# CONSERVATION COMMISSION AGENDA

June 24, 2021

- (7:00) Crystal Lake – Left Beach Safety Enhancements – NOI – DEP File 239-XXX**
  - Owner: City of Newton Representative: Nicole Banks, Commissioner and Luis Perez Demorizi, Open Space Coordinator, Newton Parks, Recreation and Culture

## Crystal Lake "Left Beach" Removal Plan

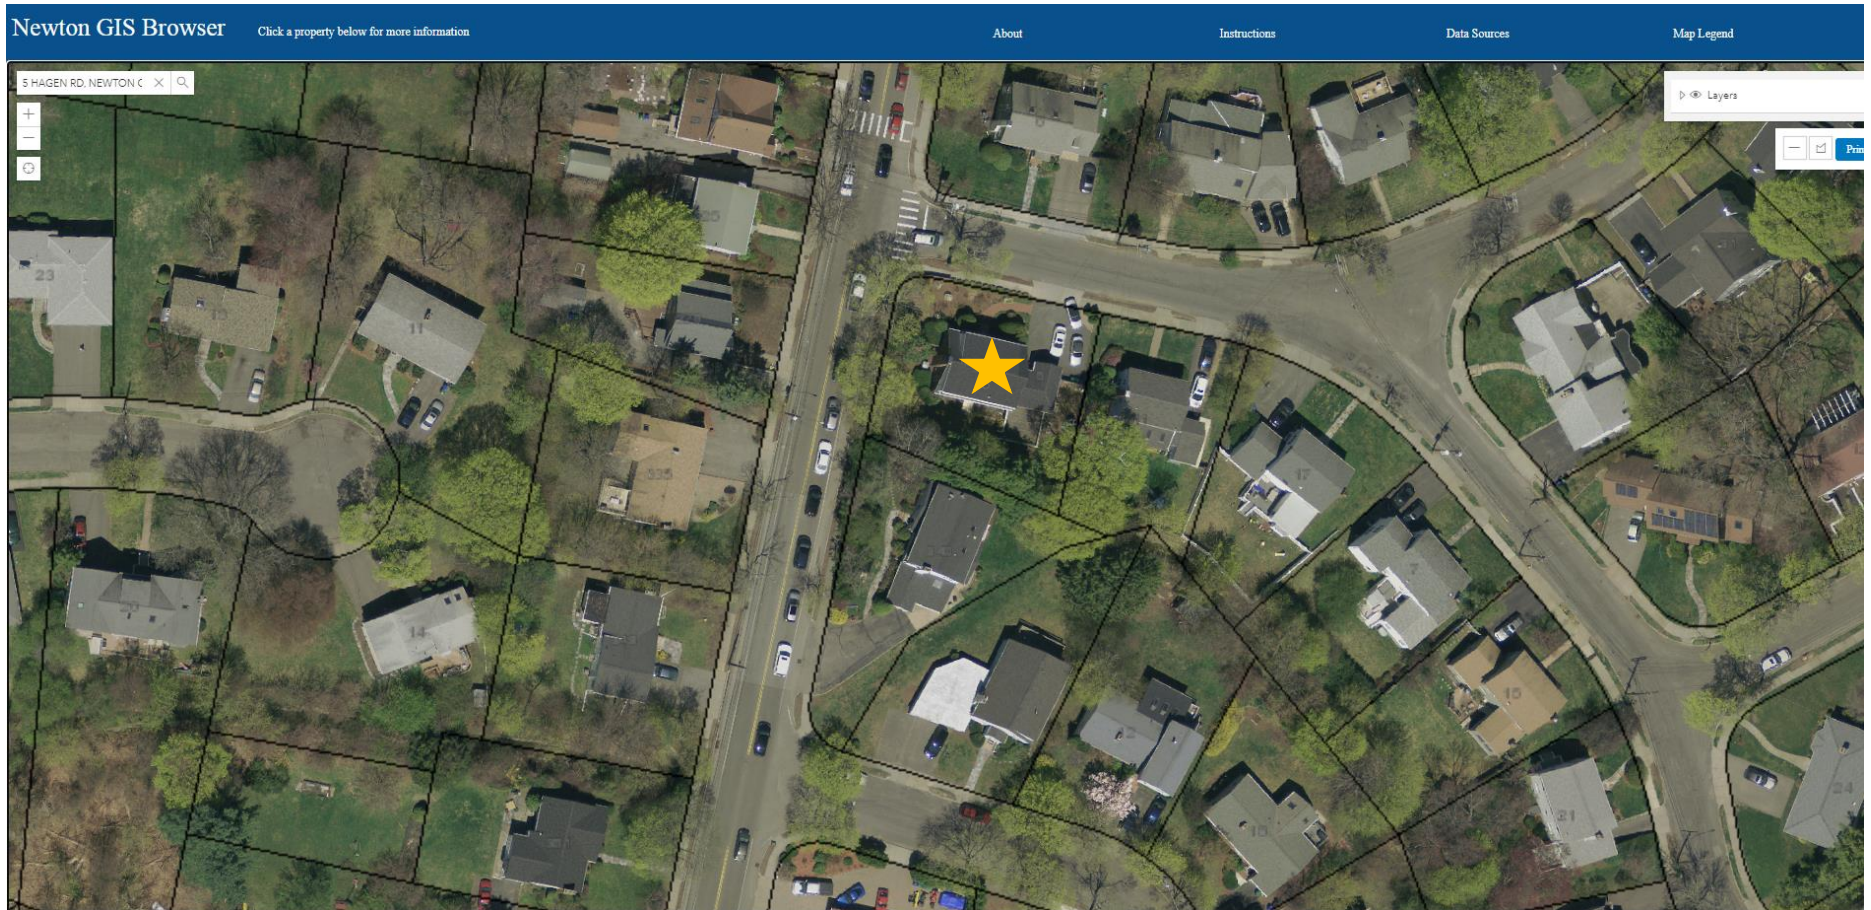
- Rake existing sand back toward the shore to fill where the timbers and benches were removed and to meet existing grade.
  - **Staff Notes**
    - Applicant should clarify what equipment will be used for the removal of the benches/footing and timber wall/footings.

- Applicant should clarify whether any fencing will need to be installed to prevent public access to this area during construction.
- Applicant should clarify where and how guard chairs are to be installed/secured.

- No sand shall be added to the beach area without the filing of a new Notice of Intent.
  - Raking of sand by hand may occur as needed to keep sand near the base of the retaining wall.

**5 Hagen Rd.  
Fence Replacement**

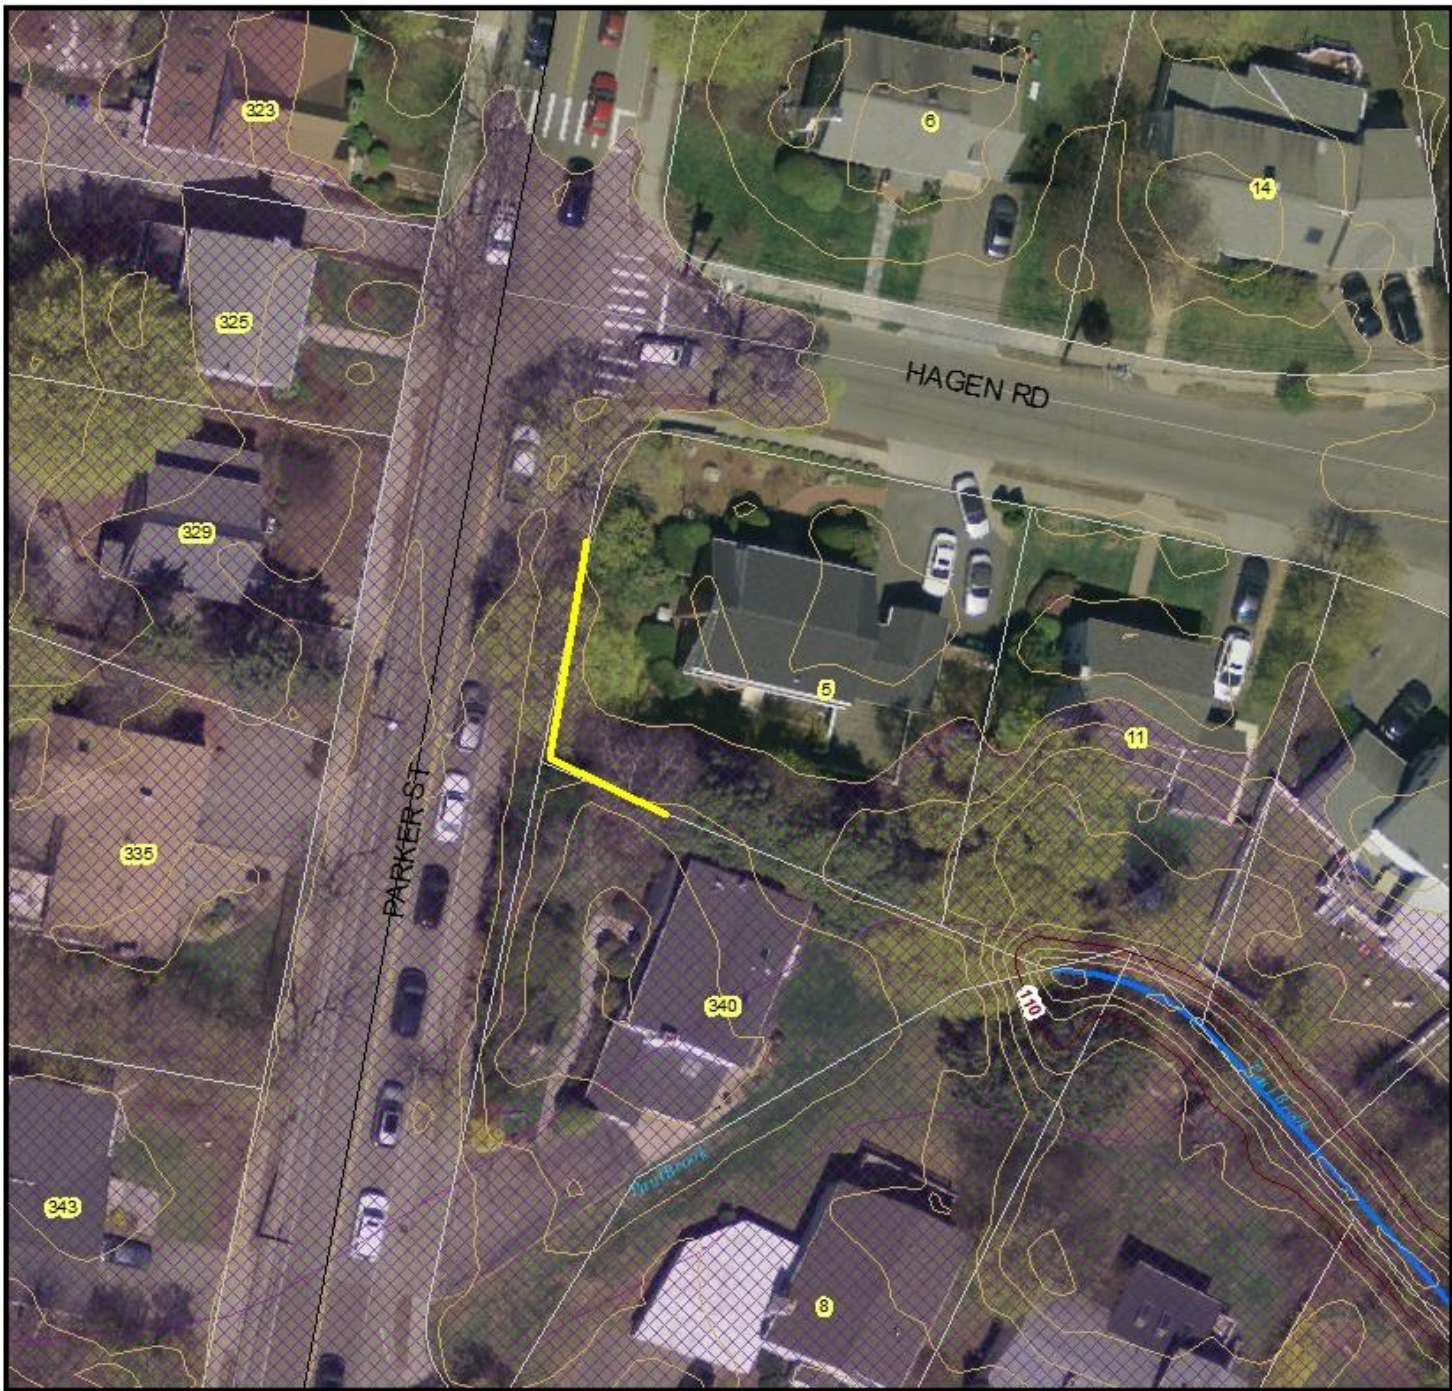
- Project Summary
  - Replace roughly 80’ of existing damaged tongue and groove, wooden fencing within.
- Staff Notes
  - Damage was done to the existing fence by sidewalk plows on Parker Street.

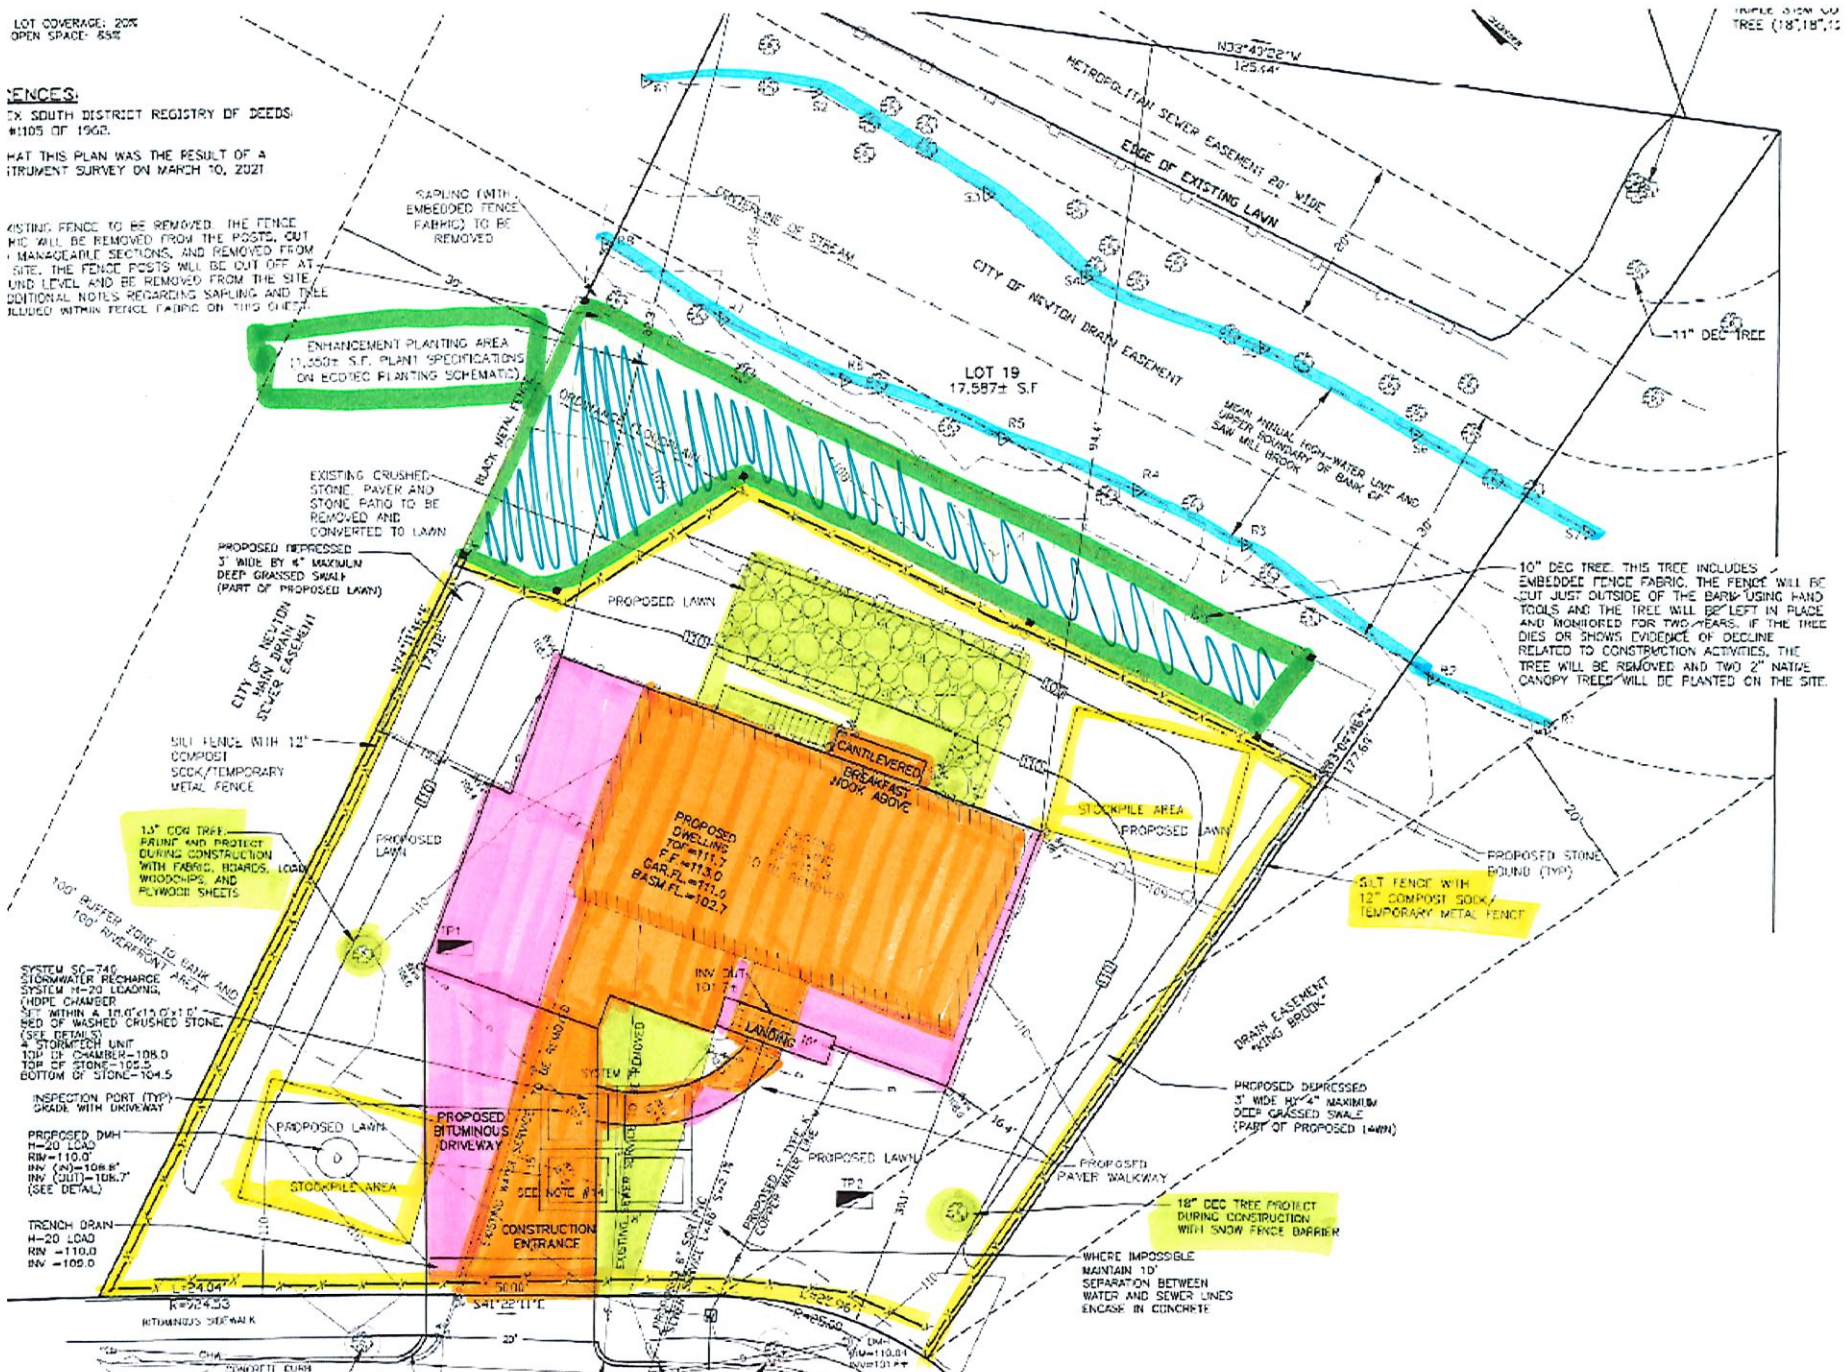
- Staff Notes:
    - Revised plans have been submitted reducing the fill brought on site, adding swales along the southern and northern property lines to capture run-off travelling towards the abutting lots, reducing the proposed impervious area expansion, and eliminating the enhancement planting area on the east side of the stream.

- The revised planting area is now 11' wide in its narrowest section, meeting the Commission's new policy.
    - This plan provides very little lawn. Staff are concerned that there will be future requests for increased lawn space, as has been seen in similar project proposals.
